Amendments to the Drawings:

Annotated Sheet Showing Changes to Fig. 8 on Sheet 4/5

TEKTRONIX, INC.
P.O. Box 500 (50-LAW)
Beaverton, OR 97077
(503) 627-5068
6963 US

FIG. 8

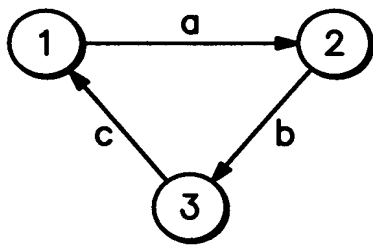
The attached sheets of drawings are formal replacements for all of the drawings previously submitted. The attached sheet of drawings include a change to Fig. 8 on sheet 4/5. In Figure 8, the direction of arrow b has been reversed to be consistent with Fig. 7 and basic understanding of a state diagram. Without this change path a and path b would be redundant, which would not be correct for a state diagram.
